Multifiber MDIs

Regarding Comment #1-33 on D3.0

Earl Parsons, CommScope

IEEE 802.3db Ad Hoc Meeting
April 14, 2022

Figure 167-9—MPO female plug with down-angled interface and MDI active device receptacle with angled interface

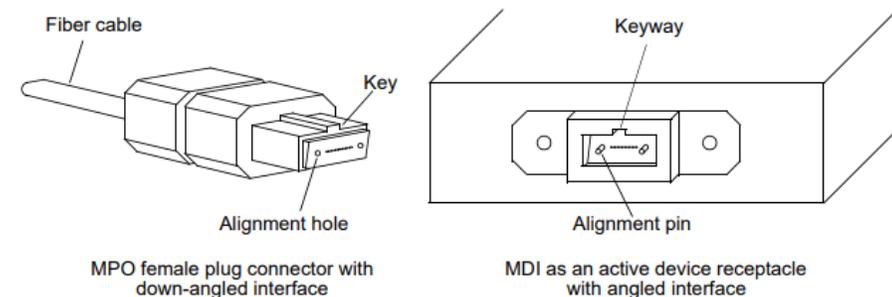
No IEC standard with grade 1m will be published in time for IEEE 802.3db

- The last sentence in 167.10.3.3 refers to grade Bm/1m
- Grade 1m is currently undefined in these publications
- Grade 1m defined in drafts as
 - ≥ 45 dB mated
 - ≥ 35 dB unmated
- IEC 63267-1 (APC MM interface specification) is scheduled to publish in January 2023, after September 2022, when we expect 802.3db to publish
- Informative APC option could be considered by the Task Force

Use D1.2 Option B for PC

- Change 167.10.3.3 with editorial license to:
- The MDI shall optically mate with the compatible plug on the optical fiber cabling. For 200GBASE-VR2, 400GBASE-VR4, 200GBASE-SR2, and 200GBASE-SR4 the MDI adapter or receptacle shall meet the dimensional specifications for interface 7-1-3: MPO adapter interface - Opposed keyway configuration, or interface 7-1-910: MPO active device receptacle, ~~angled~~ flat interface, as defined in IEC 61754-7-1. The plug terminating the optical fiber cabling shall meet the dimensional specifications of interface 7-1-14: MPO female plug connector, ~~down-angled~~ flat interface for 2 to 12 fibres, as defined in IEC 61754-7-1. Figure 167-9 shows an MPO female plug connector with ~~angled~~ flat interface, and an MDI. The MDI connection shall meet the interface performance specifications of IEC 61753-1 and IEC 61753-022-2 (for category C environment) for performance grade Bm/±2m.

- Replace Figure 167-9 and caption in D3.0 with Figure 167-11 and caption from D1.2

Experimental results using commercially available 400G-SR8 transceiver

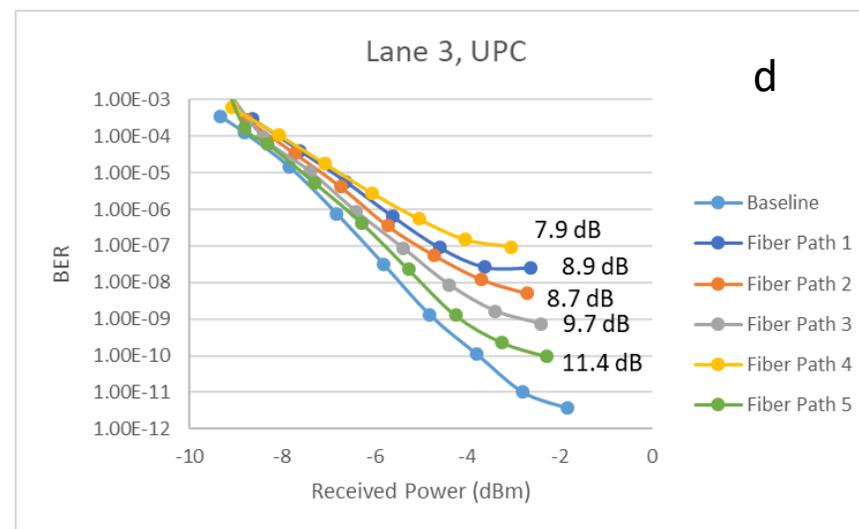
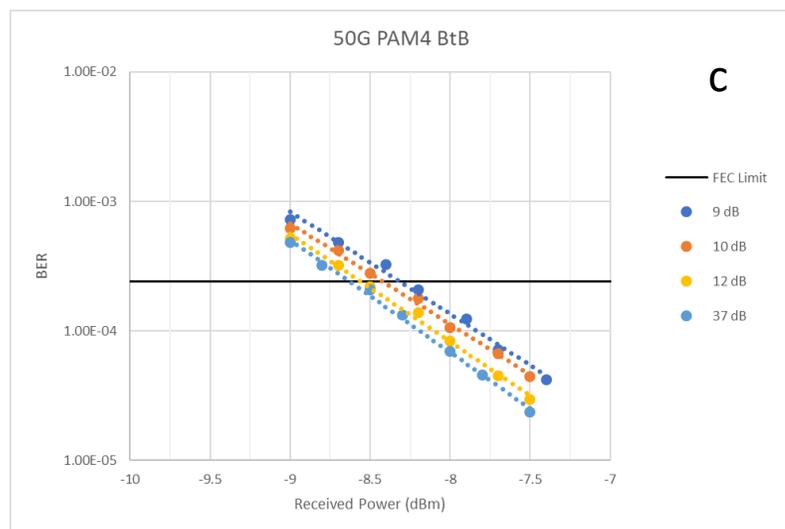
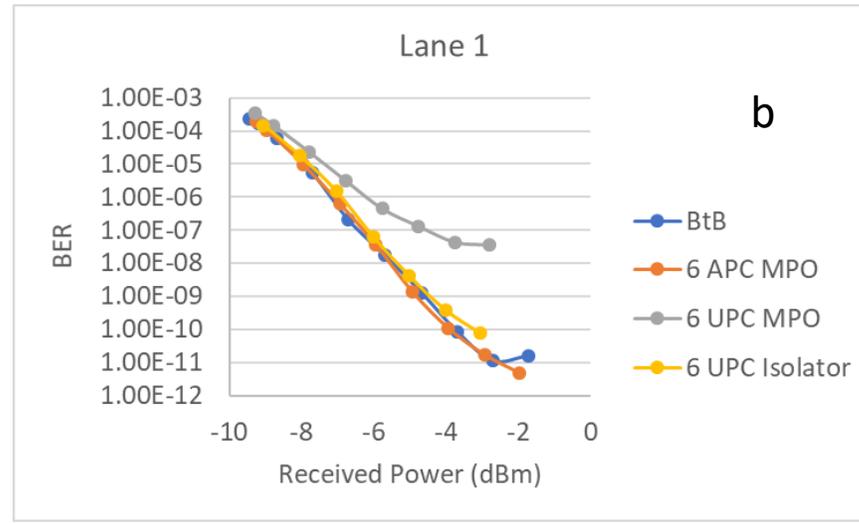
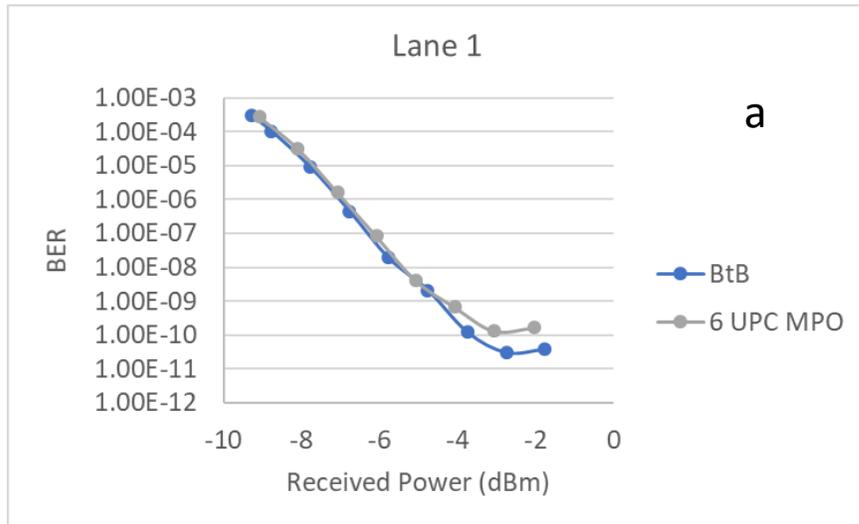
- APC connectors introduce no BER penalty (b)
- Well behaved PC connectors introduce no penalty (a)
- Air gap PC connectors introduce penalty (b)
- Penalty scales with link RL (c, d)
- Isolator eliminates penalty from air gap PC (b)
